UNITED STATES ENVIRONMENTAL PROTECTION AGENCY

May 15, 2006

Re: Supplemental Phase II Remedial Investigation Data Package Report for IRP Site 16, at the former Davisville Naval Construction Battalion Center, North Kingstown, RI

SHALLOW CVOC ISOPLETHS

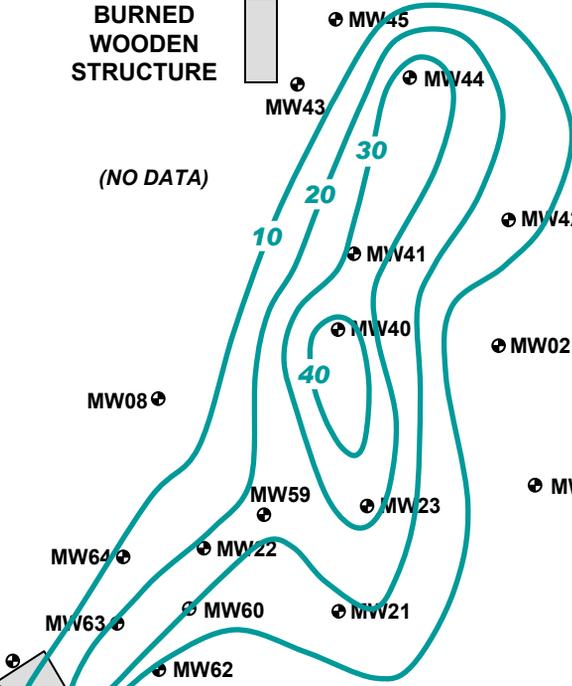
32. *Page 4-17, 2nd Paragraph, 3rd Sentence:* The text implies origin of the shallow CVOC contaminated groundwater from the former Building 41 area. This has not been established based upon the data collected, to date. Analyses performed by EPA indicate that at least a component of the contamination observed in the shallow groundwater at the location down gradient from the former Building 41 (not necessarily a plume originating from the former Building 41 area) originates from the area north of Davisville Road. Figure 1 show the EPA Contractor (GF-CDW) interpreted total CVOC distribution for the shallow groundwater using the total CVOC data supplied in this report. The highest concentrations originate from the vicinity of MW16-40 and appear to extend to the north to MW16-44 and south to MW16-23 and MW16-21. While shallow soil CVOC contamination has not been found in the vicinity of the eastern end of the former Building 41 area, significant shallow soil CVOC contamination has been detected in the area north of Davisville Road.

There are two possible explanations for this distribution. The first has been commented on in Specific Comments 1 through 3. There is a storm drain line that appears to have inverts (pipe) below the groundwater table. Infiltration into these storm drain pipes may have pulled contamination in that direction. The second explanation was briefly referenced in Specific Comment 13 which describes the middle lithologic unit and in Specific Comment 27 which discusses the CVOC concentrations noted in the soil column. Figure 2 shows a generalized depiction of the soil stratigraphy and CVOC concentrations in soil (along with filtered FID or PID readings) developed by EPA Contractor (GF-CDW). The information on this figure strongly suggests that CVOC contamination in the area north of Davisville Road has migrated down dip along the top of the silt layer to the area of MW16-59, i.e. south of Davisville Road. Therefore, the distribution of CVOC contamination in the shallow groundwater appears to be a plume emanating from the area north of Davisville Road, not the former Building 41 area.

Insert Figure 1: Shallow Total CVOC Contaminant Distribution.

**FIGURE
1**

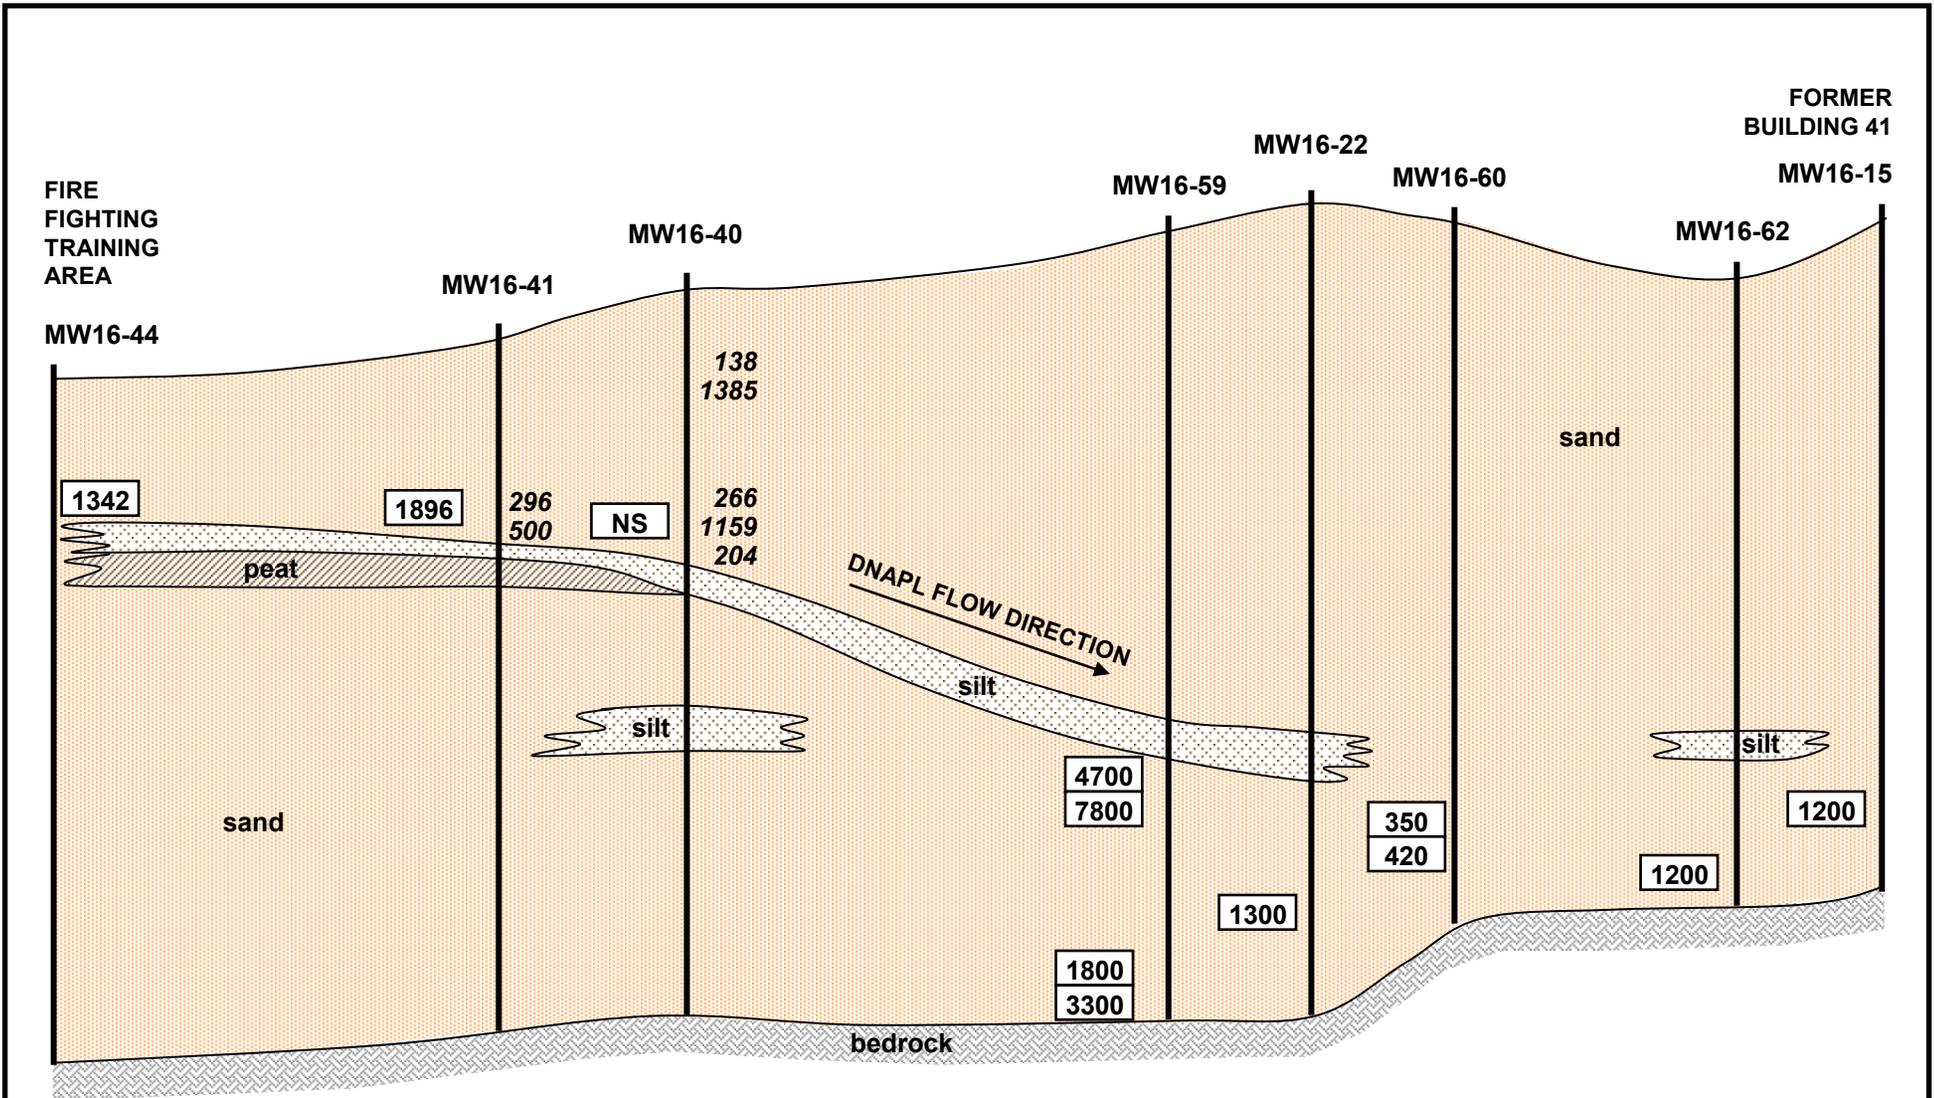
Insert Figure 2: Generalized Cross Section

FIGURE
3

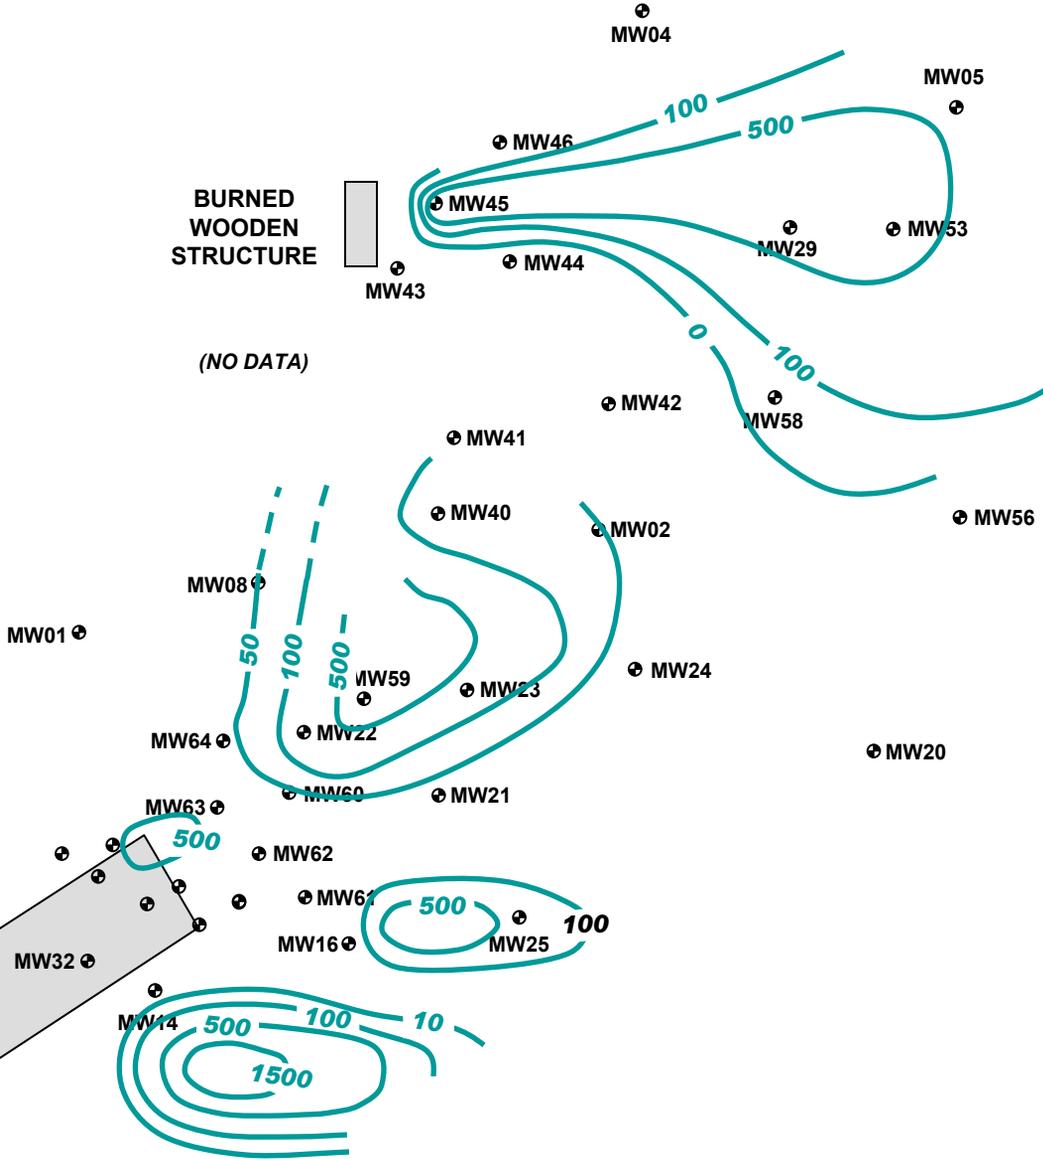
34. *Page 4-18, 3rd Paragraph:* A somewhat different interpretation of the distribution of CVOC in the intermediate overburden was developed by EPA Contractor (GF-CDW) as shown on Figure 3. This interpretation indicates that there are likely multiple source areas that move in one or more directions to contribute CVOC contamination to groundwater. While there is a pocket of elevated CVOC southeast of the former Building 41 footprint, there are at least two additional source areas. The first appears to be related to the area that appears to be contributing CVOC contamination to the shallow groundwater south of Davisville Road originating north of Davisville Road.

36. *Page 4-19, 3rd Paragraph, 2nd Sentence:* EPA does not concur that the Building 41 area is the primary origin of the CVOC in the intermediate aquifer. As shown on Figure 3, elevated CVOC is in the soil profile north of Davisville Road and not at the

Insert Figure 3: CVOC Distribution in the Intermediate Overburden Aquifer.

NCBC SITE 16 DAVISVILLE, RHODE ISLAND		
DEEP OVERBURDEN CVOC ISOPLETHS		
	CDW CONSULTANTS, INC. 40 SPEEN STREET SUITE 301 FRAMINGHAM, MA 01701 TEL. (508) 875-2657	DRAWN: JEL
		CHECKED: CGL
		DATE: 05/07/06
		SCALE: AS SHOWN
		FIGURE 4

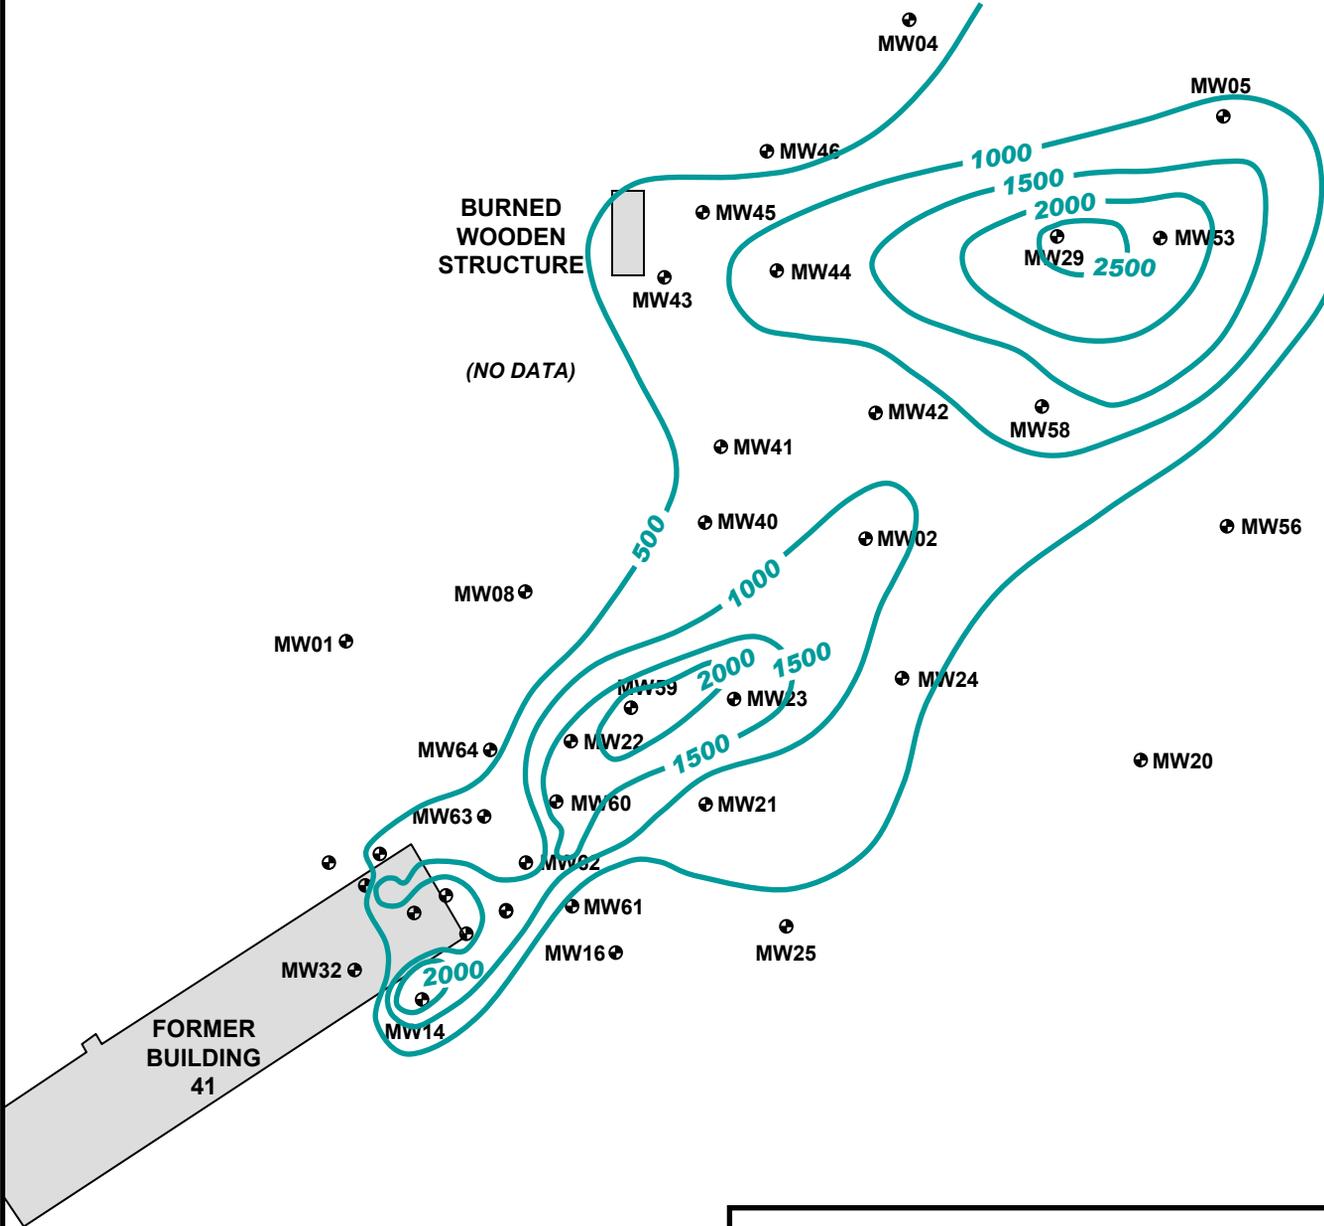
37. *Page 4-19, Section 4.3.1.3, 2nd Paragraph:* The highest CVOC in soils detected, to date, were found at MW16-59I (7,800 µg/L) at a depth of 44 to 46 feet below ground surface. This elevation is higher than that for CVOC detected in the deep overburden around the eastern end of the former Building 41 footprint. This in conjunction with other data suggests that CVOC has originated from the area north of Davisville Road (and/or from discharge from the shallow bedrock such as at MW16-14D/R originating from further up gradient to the west). As shown on Figure 4, the interpreted distribution of CVOC developed by EPA Contactor (GF-CDW) would support this as it closely resembles the distribution of CVOC in the intermediate zone. There is also a localized elevated CVOC concentration in the area of MW16-12 down gradient from MW16-14.

Insert Figure 4: Distribution of Deep Overburden CVOC

NCBC SITE 16 DAVISVILLE, RHODE ISLAND		
TOP OF SILT		
	CDW CONSULTANTS, INC. 40 SPEEN STREET SUITE 301 FRAMINGHAM, MA 01701 TEL. (508) 875-2657	DRAWN: JEL
		CHECKED: CGL
		DATE: 05/07/06
		SCALE: AS SHOWN
		FIGURE 5

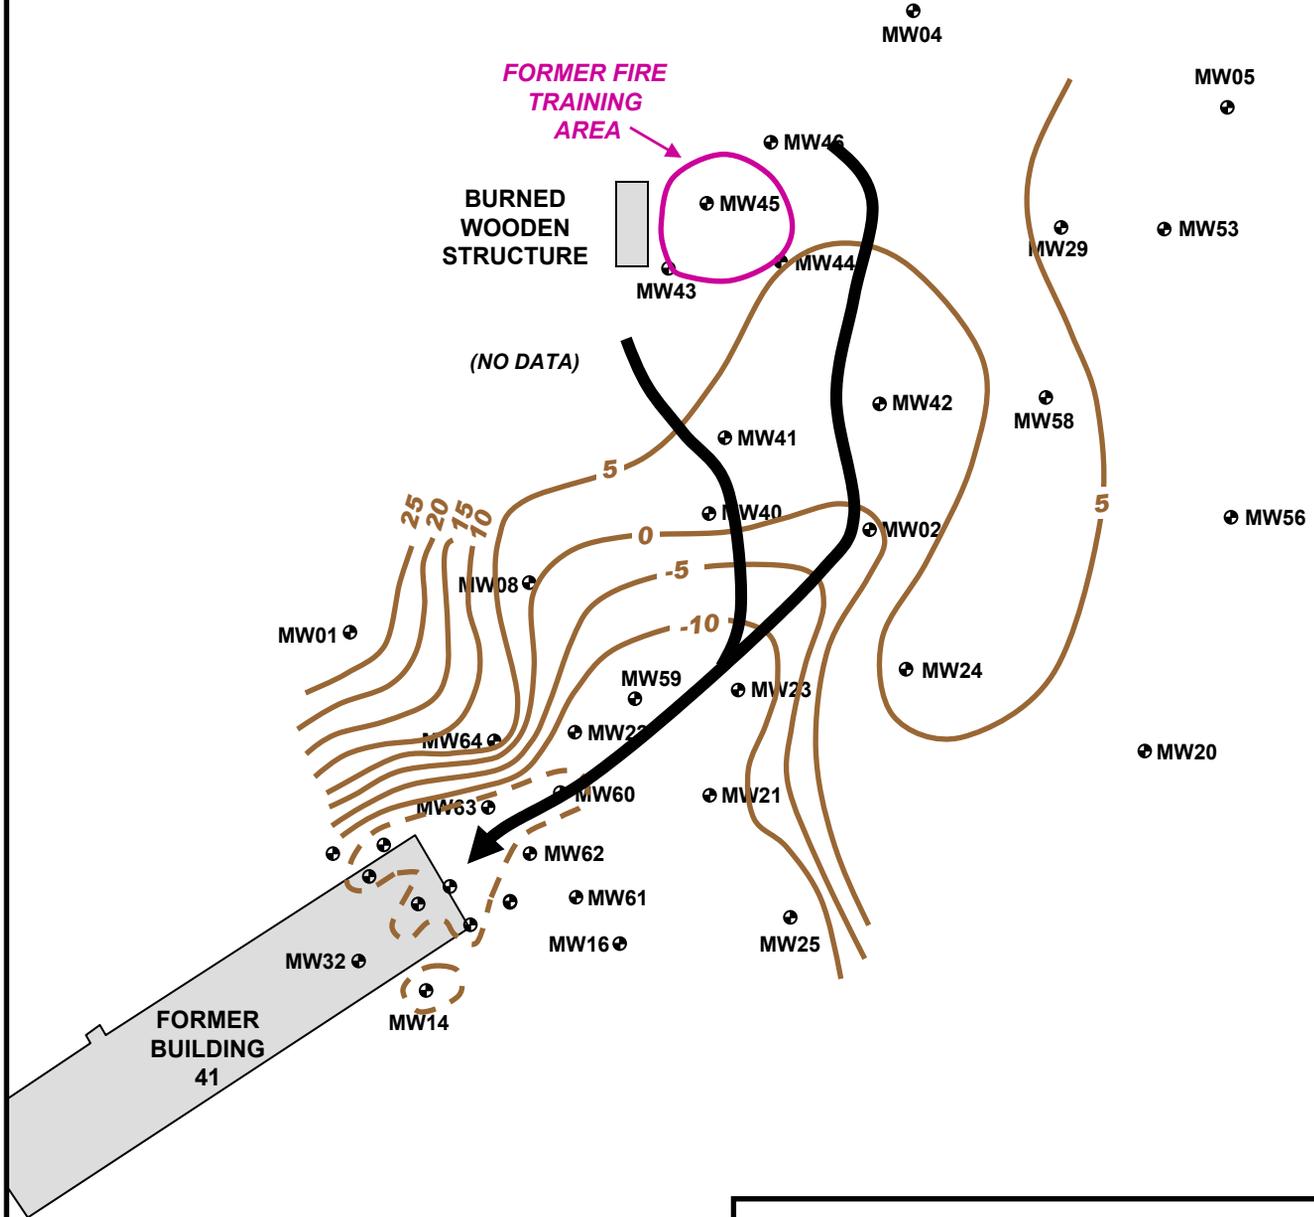
A further indication for the origin of CVOC at a location other than the eastern end of the former Building 41 area is the distribution of the top of silt elevations for Site 16. A generalized depiction of the top of silt was prepared by EPA Contractor (GF-CDW) and is shown on Figure 5. The top of silt was interpreted from soil boring logs with silt being defined as a definite silt unit as opposed to sandy silt or silty sand. While the figure is generalized and interpretation of the soil boring logs may result in some minor variations of specific top of silt elevations, there clearly appears to be a trough of silt that dips from the area north of Davisville Road toward the former Building 41 footprint. Of special note is the absence of a silt layer entirely in the area of the eastern end of the former Building 41 area. As depicted by the arrows, the likely pathway for DNAPL released in the area north of Davisville Road would be counter to the general groundwater flow direction down the dipping silt layer to the area where the silt disappears. However, this is a characteristic physical feature of DNAPL migration.

This contaminant pathway correlates with the distribution of CVOC noted in the shallow overburden groundwater distribution and the intermediate groundwater CVOC distribution. It also correlates with the stratigraphy of dipping silt, disappearance of the silt layer, and the distribution of CVOC in soil and from head space readings recorded during conduct of soil borings as depicted on Figure 2. There may be other contributing source areas to the observed CVOC contamination such as an undefined release at a loading dock opposite the former CVOC still, the area of the railroad yard, or as discharging groundwater from the shallow bedrock from a source further up gradient (former Nike PR 58 site). However, the major point is that the repetitive statement in this study that the source area for the CVOC “plume” is the former Building 41 area suggests that this investigation and future investigative work is focused on this area as the source to the exclusion of seriously considering other areas as potential major contributing sources, rather than just minor “small” source area additions.

Insert Figure 5: Top of Silt and DNAPL Pathway.
